Docket Items # 10 & 11  
BAR CASE # 2017-0186 &  
2017-0192

BAR Meeting  
July 5, 2017

**ISSUE:** Permit to Demolish/Capsulate and Certificate of Appropriateness for alterations

**LOCATION:** 420 South Pitt Street

EXTERIOR ELEVATIONS

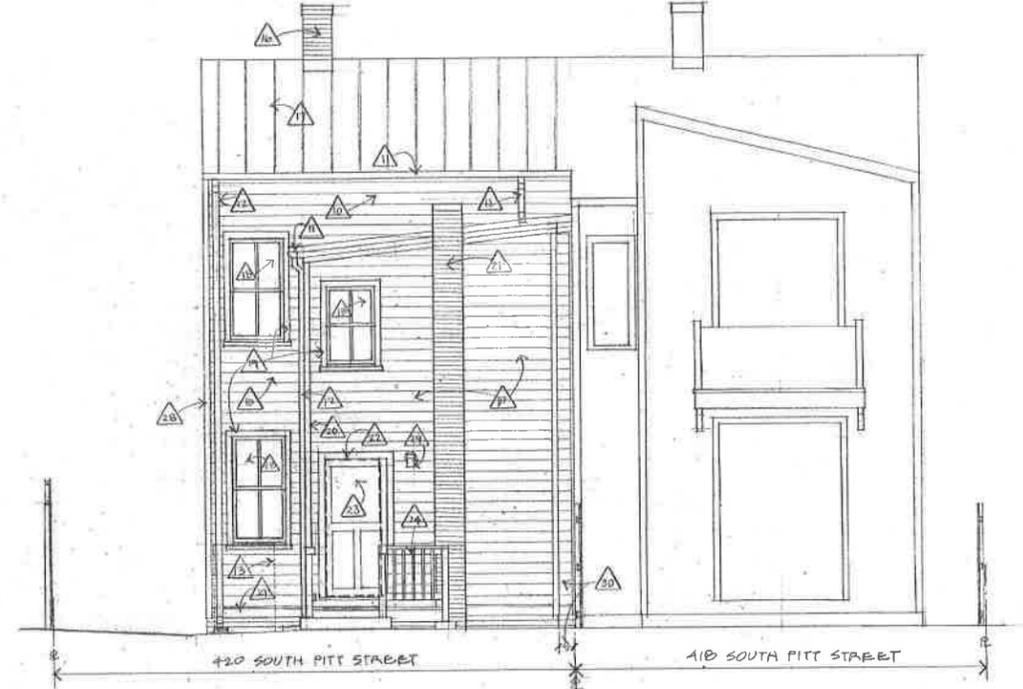
The amount of demolition is limited to just over 25 square feet for the removal of a door opening on the south elevation of the ell which is not visible from the right-of-way. The door has no remarkable or unusual features or materials nor exceptional craftsmanship and it could easily be reproduced in the future, should anyone desire to do so. Further, the removal of one of two doors on the modest rear ell will allow for a more efficient interior layout. Therefore, staff recommends approval of the Permit to Demolish.

Staff typically supports the use of modern materials on new construction, on elevations with limited visibility from the public right-of-way, and where routine maintenance is difficult or impossible. In this case, staff can support the use of modern materials, given the extremely limited visibility of the rear ell. As Figure 1 shows, only portions of the ell are visible from a significant distance. The ell is visible from South Royal Street by a distance of over 200'. While the view from South Pitt Street from a shorter distance, very little of the ell is visible from this oblique view. It would not be feasible at these distances to differentiate the building materials.

Approval of the Permit to Demolish/Capsulate and Certificate of Appropriateness, as submitted.
